## **Stage 1/2 Road Safety Audit**

**Ballincor Wind Farm**

**On behalf of RWE Renewables Ireland Limited**

#### 4.1.2 L1071 & R491 Junctions – Livestock

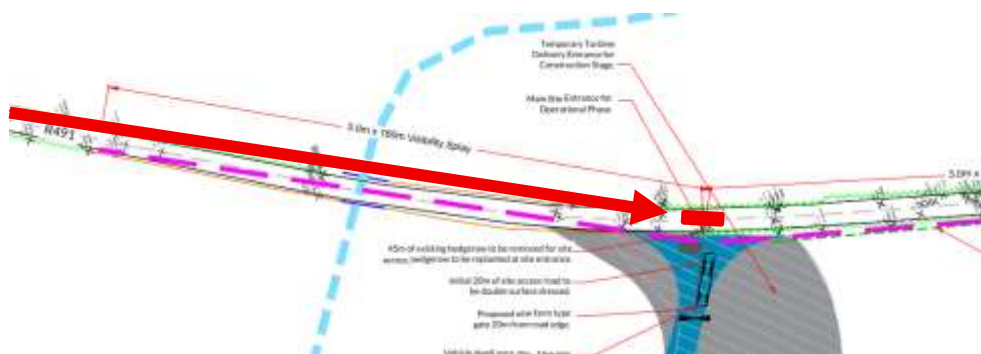
**Problem:** The proposed development access roads are through existing agricultural lands. There is no fencing or gates shown for this access. There is concern livestock may access the development roads and wander onto the public roads.

**Hazard:** Public road traffic may impact with livestock.

**Recommendation:** The Design Team should ensure no livestock can gain access to the public roads due to these proposed works.

4.1.2	Yes	Yes		
4.1.3	Yes	Yes		
4.2.1	Yes	Yes		
4.2.2	Yes	Yes

### 4.2.1 R4921 Junction Radii

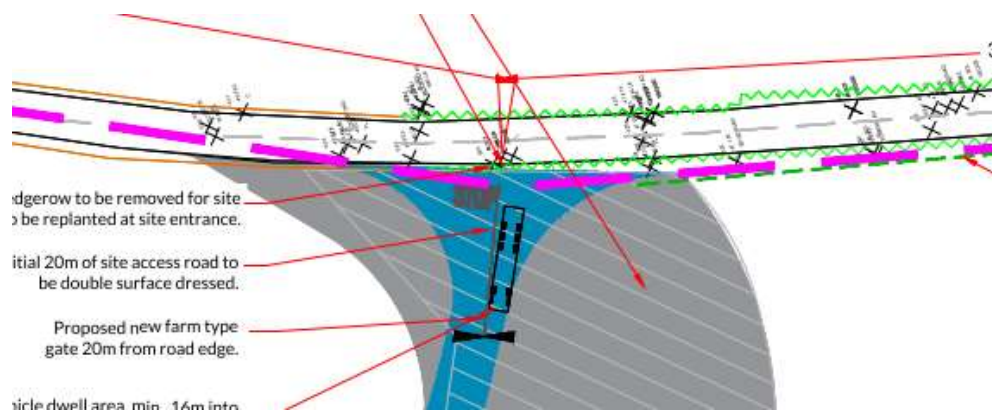
**Problem:** The R491 junction radii for the operational phase of the development appears large. There is risk development traffic may exit left off the R491 at high speeds and lose vehicle control. Additionally, development traffic waiting to enter the R491 by turning left may align their vehicle at an acute angle, thereby the driver being required to look over their right shoulder to view approaching traffic. The driver may not see smaller vehicles approaching i.e. two-wheeled vehicles.

**Hazard:** Development traffic may impact with other road users or roadside hazards.

**Recommendation:** The Design Team should undertake vehicle swept path analysis and reduce the junction radii accordingly.

#### 4.2.2 L1071 Junction – Conflicts

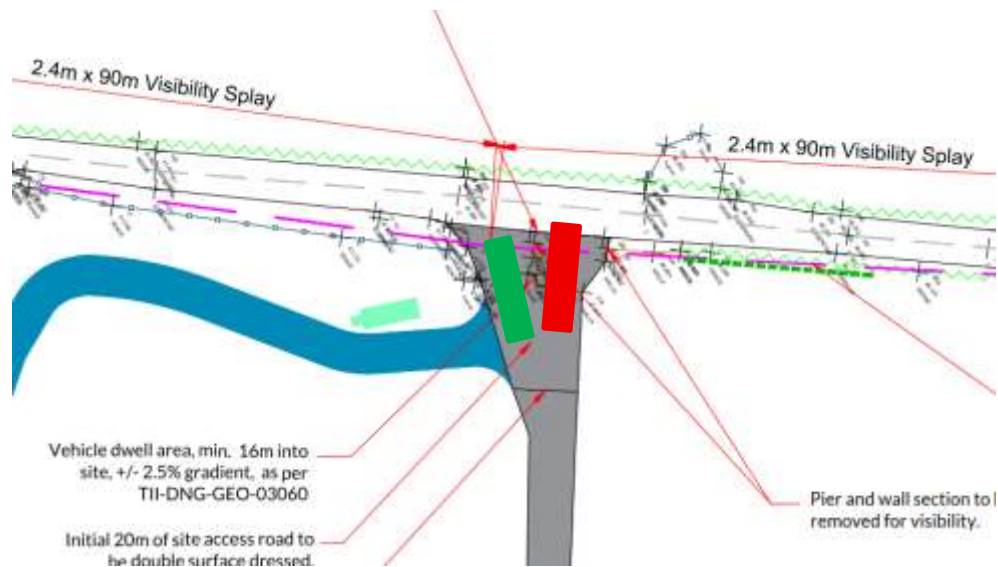
**Problem:** The development site access forms a junction with the farm access in close proximity to the L1071 carriageway. Development traffic may turn off the L1071 but may not be able to fully clear the junction due to farm traffic waiting to join the L1071.

**Hazard:** Rear end shunts may result.

**Recommendation:** The Design Team should amend the junction arrangement to ensure vehicles do not become stranded with the rear end protruding into the L1071 carriageway.
